RN SERIES TECHNICAL BULLETIN

ISSUE NO. : RNT-002

SUBJECT: 021-19112-101 Spring; Lock Hook

021-19112-101 Spring; Lock Hook

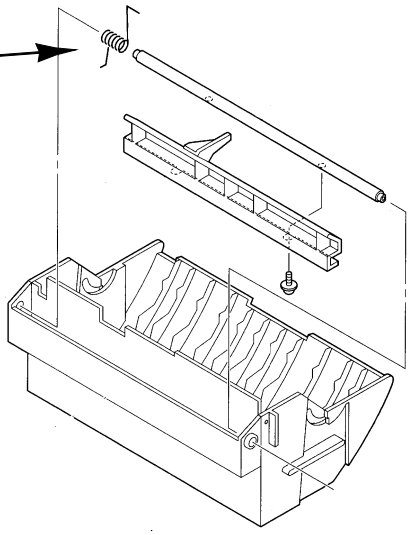
The spring has been made 50% stronger, and the part number is changed from 021-19112-004 to 021-19112-101.

The former spring may become too weak to snap back the Lever Handle of the master disposal box when the box is inserted back in the machine after disposing the used master accumulated in the box.
The premature snap back of the Lever Handle causes the master disposal safety switch not to activate.

021-19112-004 Spring; Lock Hook was "Black" in color, while the new 021-19112-101 Spring; Lock Hook is "Reddish Gold" in color, with the exception that first productioin lot of 1,700 pieces are "Black" in color.
